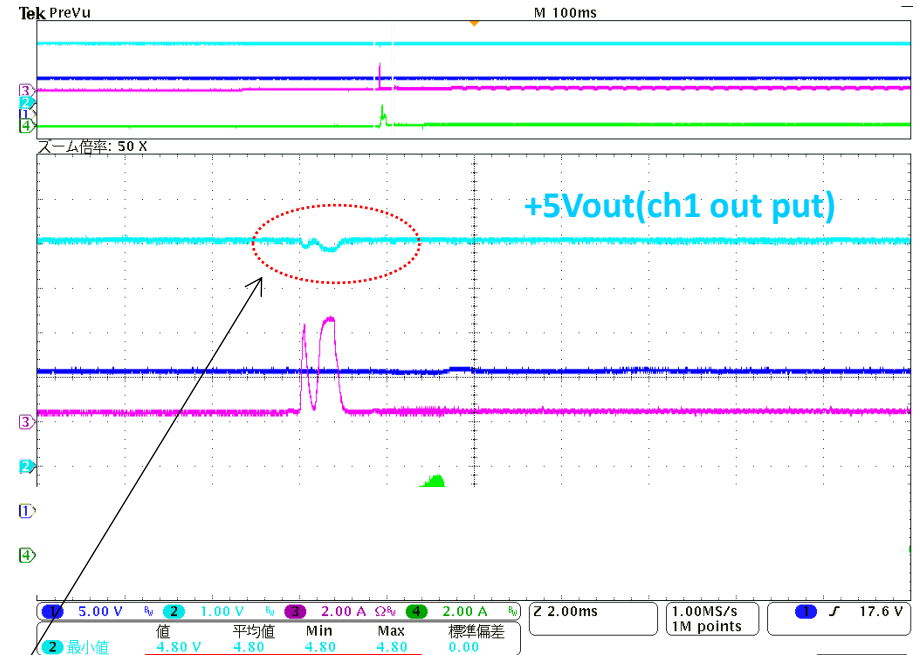
Rsense : 0.01//0.01//0.003ohm (parallel connection)

Rsense : 0.003ohm

When the load current increases, the output voltage to drop.
 The voltage drop is dependent on the Rsense.
 Is there something that is considered to be the cause of that?
